## Joint Inspection Report of 5 MLD STP Shuklaganj

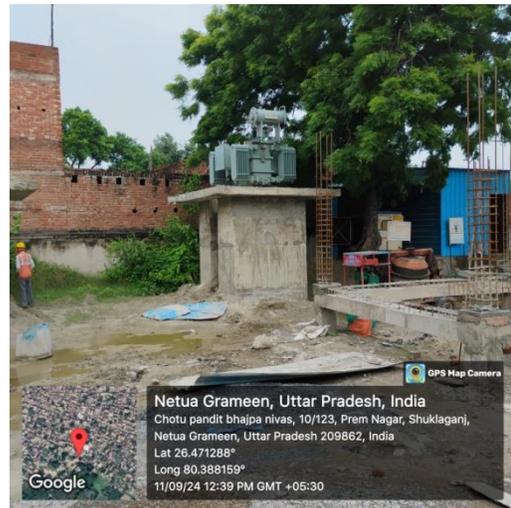
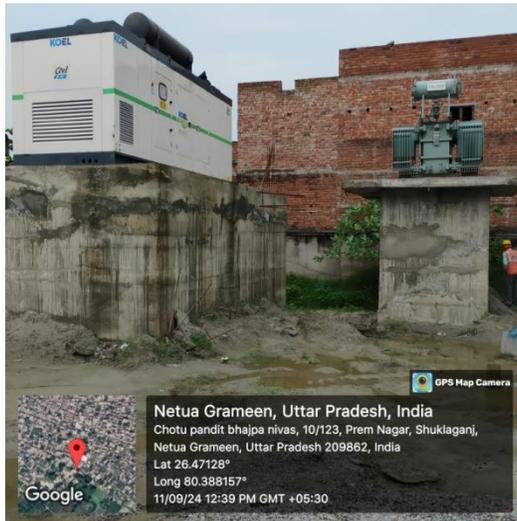
**Admin building cum Blower room-** In admin building room first floor and second floor slab work pending, brick work IPS flooring, electrification, sanitary fitting & plumbing, beam, column works are pending. In blower room roof slab, brick work, IPS flooring, roof treatment & finishing works are pending. EE UPJN advice to clean the open steel bar and coat with cement slurry, also advised for better housekeeping.
